UNITED STATES PATENT AND TRADEMARK OFFICE

APPLICATION NO.	FILING DATE	FIRST NAMED INVENTOR	ATTORNEY DOCKET NO.	CONFIRMATION NO.
10/688,303	10/15/2003	Kentaro Nagoshi	SIW-067	9456

Office Action Summary

DETAILED ACTION

Figure 1 below illustrates the gas diffusion layer 2 and the separator 1 adjacent to each other; the gas flow channels 5 and 6; and the welding parts 10.

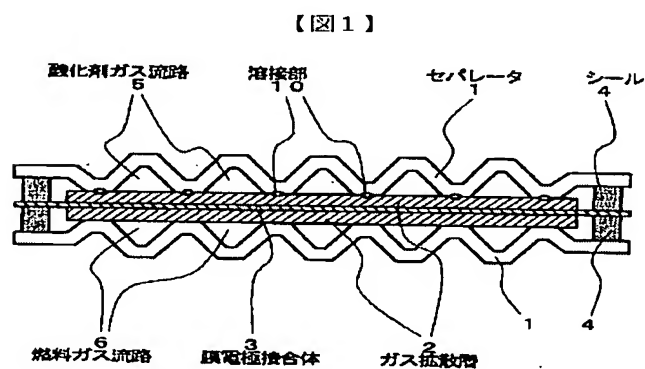
Both the gas diffusion layer and the metallic separator are bonded by resistance welding at a welding part 10. *Thus, they are welded together.*

1st Examiner's note: *It is noted that the instant claims are being construed as product-by-process claims and that the product itself does not depend on the process of making it. Accordingly, in a product-by-process claim, the patentability of a product does not depend on its method of production. In that, it is further noted that the product in the instant claims is the same*

As shown above in **Figure 1**, the combination of the corrugated separators 1 and the welding parts 10 allows the formation of reactant passages 5 and 6 (See Figure 1). *Note: the part connecting separator plate 1 and diffusion layer 2 clearly forms partitions in the diffusion layer; consequently, oxidizing gas or fuel pathways are formed. Additionally, welding part 10 formed in the diffusion layer is also part of the partition formed therein.*

2nd Examiner's note: *as to the limitation "the separator being substantially flat", the examiner notes that non-corrugated areas of the disclosed separator 1 are flat. That is to say, each and every segment of the separator 1 (See Figure 1) that is not angled is flat, and thus, it meets the claimed requirement of being "substantially flat" at those specific locations. Note that the examiner is not stating that the entire area or entire perimeter or entire length of the separator is flat per se, but the examiner is stating herein that even though the separator disclosed by the JP '153 is corrugated, such a corrugated separator further comprises non-corrugated areas having a substantially flat shape. Yet further, the examiner contends that the two ends of the disclosed separator meet the requirement of being substantially flat because applicant has not further specified whether the entire separator, or the central area thereof or ends thereof is(are) flat.*

As appreciated from viewing **Figure 1** above, the combination of the corrugated separators 1 and the welding parts 10 allows the formation of reactant passages 5 and 6 (See Figure 1). Note that the part connecting separator plate 1 and diffusion layer 2 clearly forms partitions in the diffusion layer; consequently, oxidizing gas or fuel pathways are formed. Additionally, welding part 10 formed in the diffusion layer is also part of the partition formed therein.

The JP'153 discloses a separator as seen and discussed supra. Nonetheless, the preceding prior art reference fails to explicitly disclose the entire area of the separator being substantially flat; and the specific height of flow passage partition.

In light of the above, it would have been obvious to a person possessing a level of ordinary skill in the pertinent art at the time the invention was made to make the separator of the JP'153 by being entirely flat (the entire area thereof being substantially flat) because it is prima-facie obvious to change the shape of a feature/article. It is to be noted that changes in shape is a matter of choice which a person of ordinary skill in the art would have found obvious absent persuasive evidence that the particular configuration of the claimed separator assembly is significant. In re Dailey, 149 USPQ 47. It is also noted that aesthetic design changes having no mechanical function cannot be relied upon to patentably distinguish the claimed invention from the prior art. In re Seid, 73 USPQ 431. (See MPEP 2144.04 [R-1] Legal Precedent as Source of Supporting Rationale)

With respect to the specific height of flow passage partition, it would have been obvious to a person possessing a level of ordinary skill in the pertinent art at the time the invention was made to make the flow passage partition of the separator of the JP'153 by having the specifically claimed height because where the only difference between the prior art and the claims is a recitation of relative dimensions (*i.e. changes in size/proportion*) of the claimed feature and a feature having the claimed relative dimensions would not perform differently than the prior art device, element, or member, the claimed device, element, or member is not patentably distinct from the prior art device, element, or member. That is, limitations relating to the size of the feature, element, or member are not sufficient to patentably distinguish over the prior art as it is

Figure 4 below of the JP'153 illustrates the inclusion of separator layers forming cooling water passages 7. Note that such separator layers are joined together or bonded to form the cooling water passage structure. Enlarged portion of Figure 4 better illustrates this configuration.

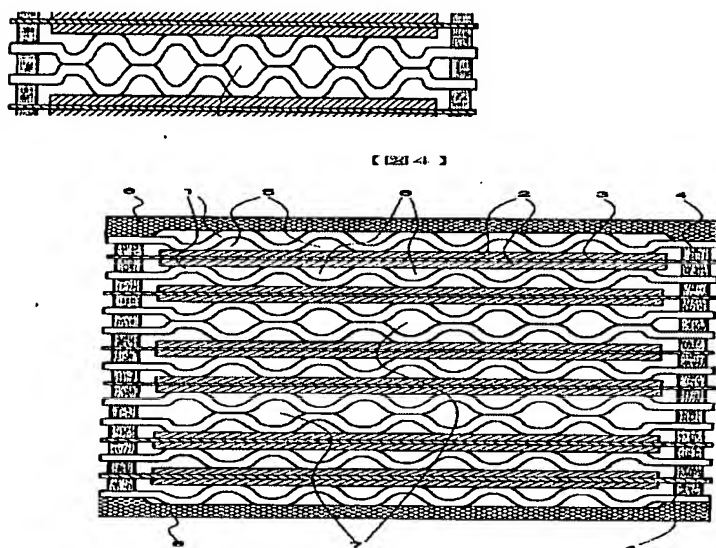
11. Finally, applicant has contended that "*JP 200-208153 does not disclose that a cooling layer and a separator are welded together*". However, **Figure 4** above depicts the inclusion of separator layers forming cooling water passages 7. *Note that such separator layers are joined together or bonded to form the cooling water passage structure.*

Figure 1 below illustrates the gas diffusion layer 2 and the separator 1 adjacent to each other; the gas flow channels 5 and 6; and the welding parts 10.

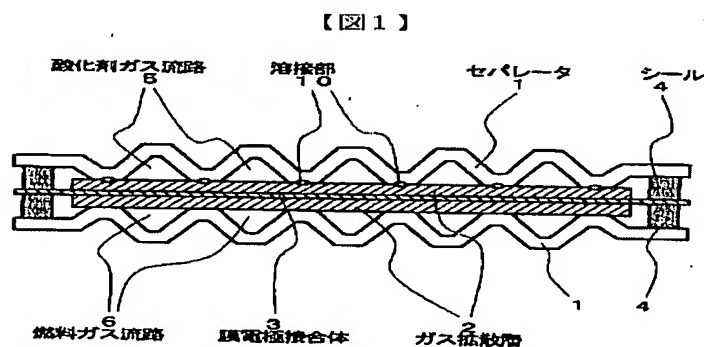
As shown above in **Figure 1**, the combination of the corrugated separators 1 and the welding parts 10 allows the formation of reactant passages 5 and 6 (See Figure 1). *Note: the part connecting separator plate 1 and diffusion layer 2 clearly forms partitions in the diffusion layer; consequently, oxidizing gas or fuel pathways are formed. Additionally, welding part 10 formed in the diffusion layer is also part of the partition formed therein.*

2nd Examiner's note: *as to the limitation "the separator being substantially flat", the examiner notes that non-corrugated areas of the disclosed separator 1 are flat. That is to say, each and every segment of the separator 1 (See Figure 1) that is not angled is flat, and thus, it meets the claimed requirement of being "substantially flat" at those specific locations. Note that the examiner is not stating that the entire area or entire perimeter or entire length of the separator is flat per se, but the examiner is stating herein that even though the separator disclosed by the JP '153 is corrugated, such a corrugated separator further comprises non-corrugated areas having a substantially flat shape. Yet further, the examiner contends that the two ends of the disclosed separator meet the requirement of being substantially flat because*

As appreciated from viewing **Figure 1** above, the combination of the corrugated separators 1 and the welding parts 10 allows the formation of reactant passages 5 and 6 (See Figure 1). Note that the part connecting separator plate 1 and diffusion layer 2 clearly forms partitions in the diffusion layer; consequently, oxidizing gas or fuel pathways are formed.

Ong et al disclose the use of flat separator plates in fuel cells (COL 1, lines 25-29).

In view of the above, it would have been obvious to a person having ordinary skill in the art to replace the corrugated separator plate of the JP'153 with the flat separator plate of Ong et al as Ong et al disclose that the overall cost of a fuel cell stack can be greatly diminished if flat separator plates can be used in place of corrugated separator plates. Thus, Ong et al directly suggest the use of flat separator plates for purposes of cost reduction so as to avoid the use of complex and costly corrugated plates. *Note that other than being complex and of high cost, Ong et al do not disclose any other technical disadvantage to using corrugated plates. Therefore, Ong et al's preference of flat separator plates over corrugated separator plates is based on cost reduction rather than a technical disadvantage. As such, Ong et al does not teach away from using corrugated separator plates due to mechanical, structural or technical drawbacks.* In further support of that, it is contended that it is prima-facie obvious to change the shape of a feature/article. In general, change in shape is a matter of choice which a person of ordinary skill in the art would have found obvious absent persuasive evidence that the particular configuration of the claimed separator assembly is significant. In re Dailey, 149 USPQ 47. It is also noted that aesthetic design changes having no mechanical function cannot be relied upon to patentably

8. Applicant has contended that “JP 2002-208153 does not disclose or teach that the separator is substantially flat, and the separator and the diffusion layer are welded together”.

The examiner respectfully disagrees with applicant’s contention. As to the limitation “the separator being substantially flat”, the examiner notes that it is prima-facie obvious to change the shape of a feature/article. In general, change in shape is a matter of choice which a person of ordinary skill in the art would have found obvious absent persuasive evidence that the particular configuration of the claimed separator assembly is significant. In re Dailey, 149 USPQ 47. It is also noted that aesthetic design changes having no mechanical function cannot be relied upon to patentably distinguish the claimed invention from the prior art. In re Seid, 73 USPQ 431. (See MPEP 2144.04 [R-1] Legal Precedent as Source of Supporting Rationale).

Additionally, it is further noted that non-corrugated areas of the disclosed separator 1 are flat. That is to say, each and every segment of the separator 1 (See Figure 1) that is not angled is flat, and thus, the JP’153 teaches portions of the separator being “*substantially flat*”. Therefore, the JP’153 encompasses separators with flat portions even though the Examiner recognizes that an entire area of the JP’153’s separator is not flat.

As for the limitation “*welded*”, applicant insists on asserting that having “the separator welded by laser welding” distinguishes over the prior art. Note that such a limitation has been construed as being directed to a product-by-process limitation which adds nothing to the patentability of the separator because the method of making a product in a product claim is ineffective to overcome a rejection based on the product unless applicant demonstrates that the process of making the product produces a product with a different structure and/or superior characteristics/properties. So far, no evidence to sustain that assertion has been positively

provided or submitted. Notice please that both the gas diffusion layer and the metallic separator are bonded by resistance welding at a welding part 10. Thus, they are welded together. With respect to the specific welding technique (i.e. "laser welding"), the examiner has treated this limitation as a product-by-process limitation (See *1st Examiner Note* in the rejection above), and among other things, applicant bears the burden to demonstrate that such a claimed technique produces unexpected results and/or a different structure. One more time, no such evidence has been provided to rebut the prima-facie case of obviousness/anticipation based upon a product-by-process claim imposed by the examiner.

9. Applicant has also contended that "*JP 2002-208153 does not disclose or teach that flow passage partitions are formed in the diffusion layer so as to define a flow passage for the fuel or oxidizer in the diffusion layer*". Again, this contention is respectfully but strenuously disagreed with. As previously explained, as seen above in Figure 1, the combination of the corrugated separators 1 and the welding parts 10 allows the formation of reactant passages 5 and 6 (See Figure 1). Note that the part connecting separator plate 1 and diffusion layer 2 clearly forms partitions in the diffusion layer; consequently, oxidizing gas or fuel pathways are formed. Additionally, welding part 10 formed in the diffusion layer is also part of the partition formed therein.

【 FIG. 4 】

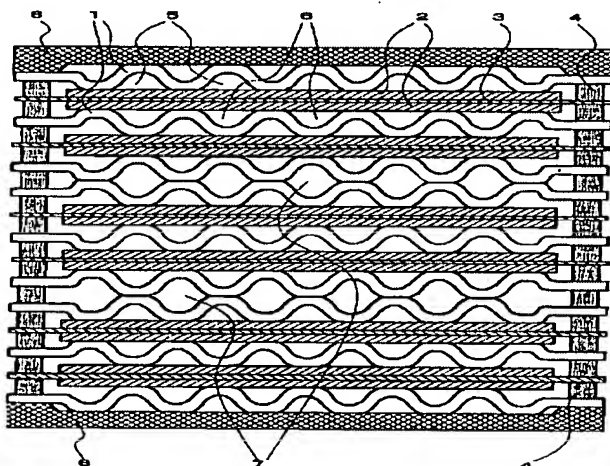
Figure 4 below of the JP'153 illustrates the inclusion of separator layers forming cooling water passages 7. Note that such separator layers are joined together or bonded to form the cooling water passage structure. Enlarged portion of Figure 4 better illustrates this configuration.
